Project	<b>IEEE 802.16 Broadband Wireless Access Working Group</b> < <a href="http://ieee802.org/16">http://ieee802.org/16</a> >	
Title	<b>Buncha figures</b>	
Date Submitted	<b>2002-01-16</b>	
Source(s)	Nico van Waes Nokia 313 Fairchild Dr Mountain View, CA 94043	Voice: Fax: <a href="mailto:nico.vanwaes@nokia.com">mailto:nico.vanwaes@nokia.com</a>
Re:	802.16, Ballot 4	
Abstract	Some complaints on figures in comment cycle, proposed modifications suggested.	
Purpose	Decision on figure replacement in 802.16a/D1	
Notice	This document has been prepared to assist IEEE 802.16. It is offered as a basis for discussion and is not binding on the contributing individual(s) or organization(s). The material in this document is subject to change in form and content after further study. The contributor(s) reserve(s) the right to add, amend or withdraw material contained herein.	
Release	The contributor grants a free, irrevocable license to the IEEE to incorporate material contained in this contribution, and any modifications thereof, in the creation of an IEEE Standards publication; to copyright in the IEEE's name any IEEE Standards publication even though it may include portions of this contribut

Figure 231—OFDMA Randomizer Initialization vector

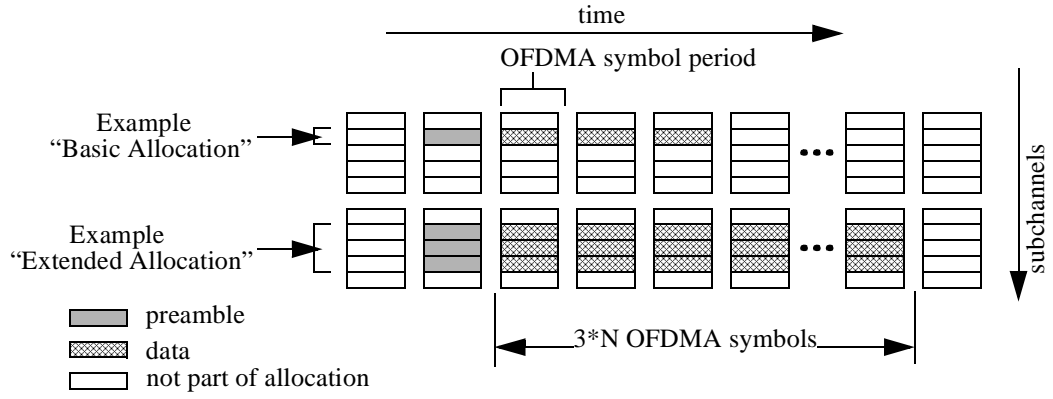
8.3.5.3.3.6.1 changes below as agreed in comment 9997 at session #16. Editorial updating was missed as stated in comment 706

The scrambler (see clause 8.3.5.3.2.1.1) is initialized with the following vector.
